AT&T Corp Generic Installation  
Exceptions

## GENERIC INSTALLATION EXCEPTIONS TO AT&T TECHNICAL PRACTICES

# **AT&T Corp Generic Installation Exceptions Preface**

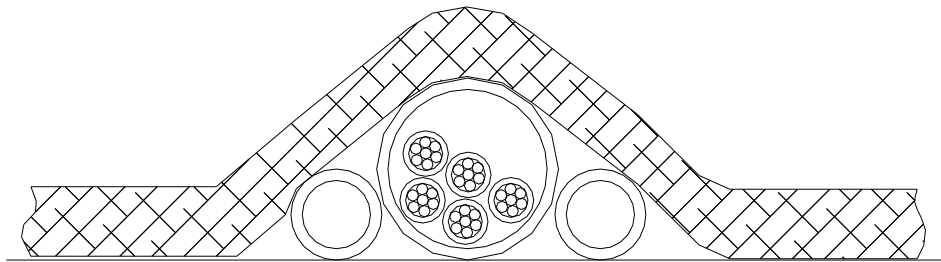
**Add R24-50** The vendor shall provide AC wiring and appropriate conduit to feed power from the customer’s AC system. AC wiring shall conform to National Electric Code.

**Add R24-51** AC wiring shall be run in an appropriate conduit per code. The conduit shall be supported from the floor pedestals (located near the top). **AT&T does not want the conduit or raceway run on the concrete slab.**
